Standard: UL 61800-5-1

Standard ID: Adjustable Speed Electrical Power Drive Systems – Part 5-1: Safety Requirements – Electrical, Thermal and Energy [UL 61800-5-1:2012 Ed.1+R:11Jun2018]

Overview of Changes:

Figure 4.14DV.1

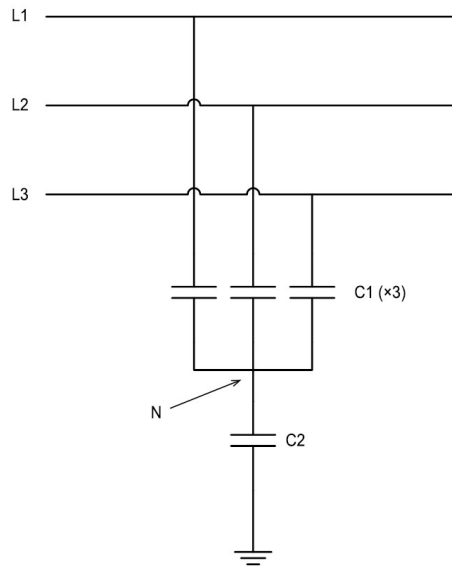
<p><i>New clause added;</i></p>
4.14DV.1.9		<p>Capacitors bridging functional and basic insulation in a center-connected network, see Figure 4.14DV.1.</p>
		<p><i>New clause added;</i></p>

4.14DV.1.9.1		<p>Capacitors designated C1 and C2 in Figure 4.14DV.1 shall be used within their marked temperature ratings.</p>
		<p><i>New clause added;</i></p>

4.14DV.1.9.2		<p>Capacitors designated C1 in Figure 4.14DV.1 shall be in compliance with one of the following with regard to the rated working voltage:</p>

Capacitors designated C1 in Figure 4.14DV.1 shall be in compliance with one of the following with regard to the rated impulse voltage:
